MDDP & DBPS AMENDMENT

BENT GRASS DEVELOPMENT

El Paso County, Colorado

DATE:
March 2020
Revised: July 2020
Revised: October 2020
Revised: January 2021

NORTHWEST DRAIN PLAN
1"=10'

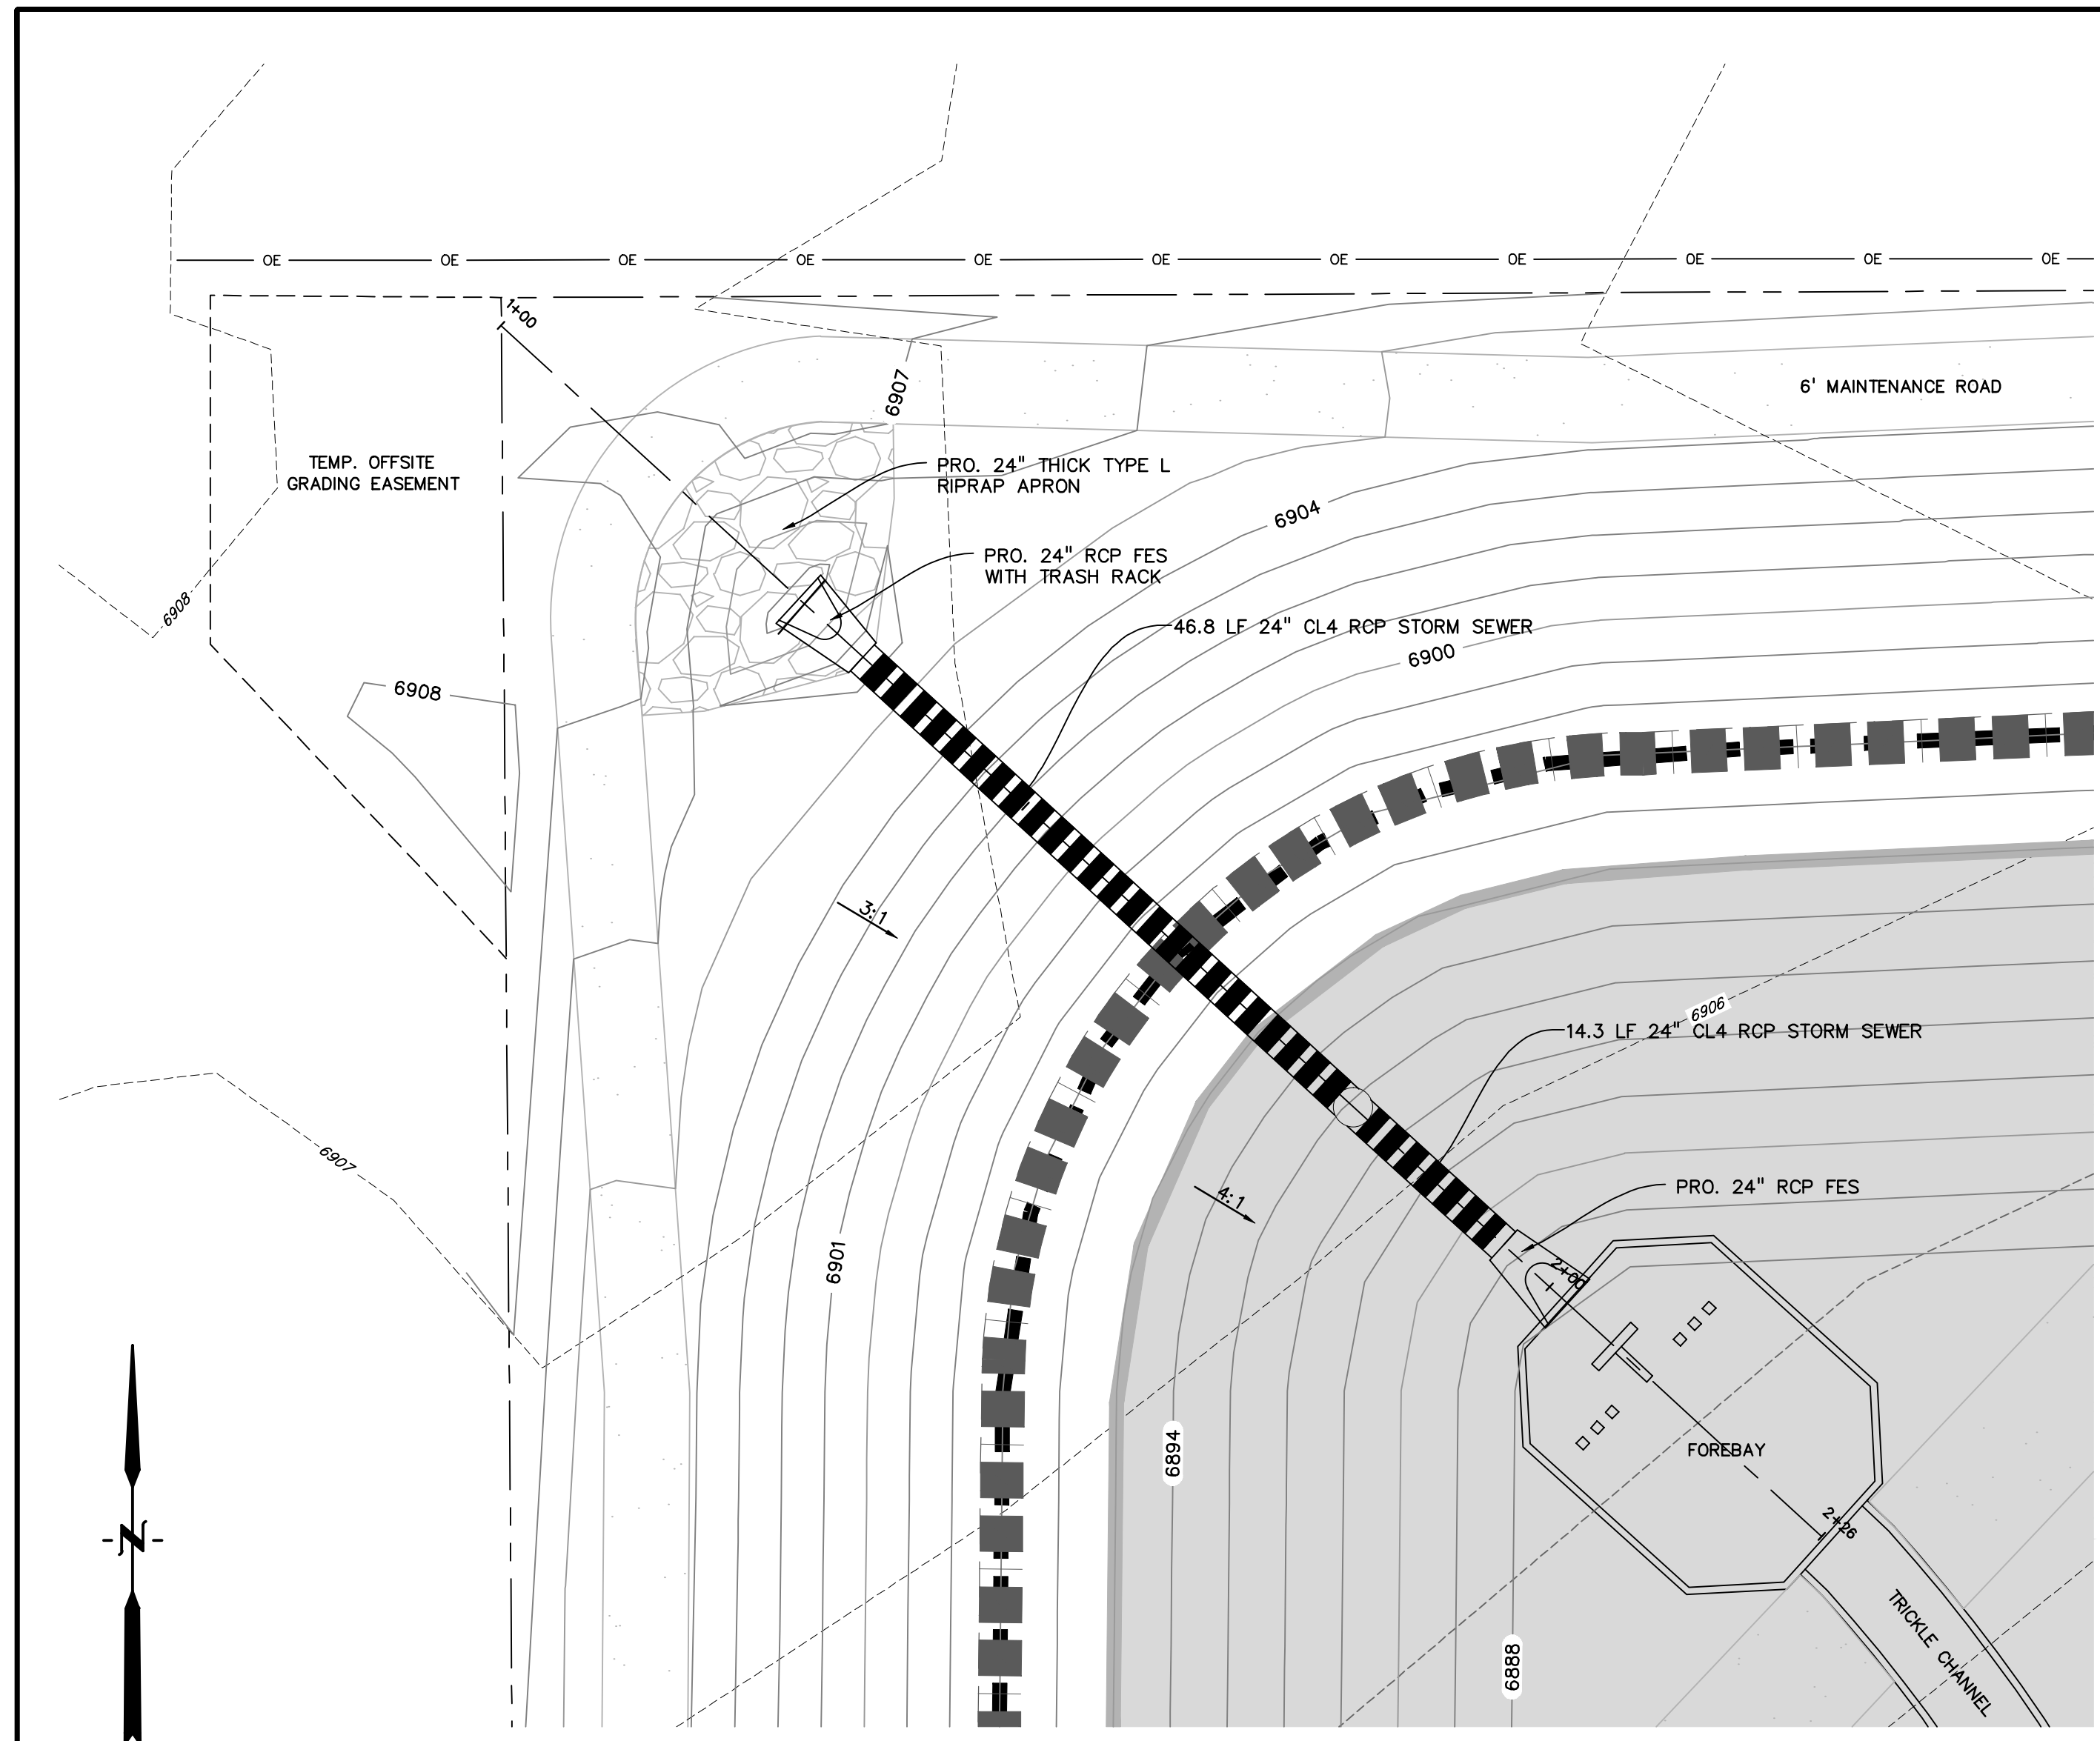
Provide latest plans and copy of Falcon Marketplace pond calcs or summary
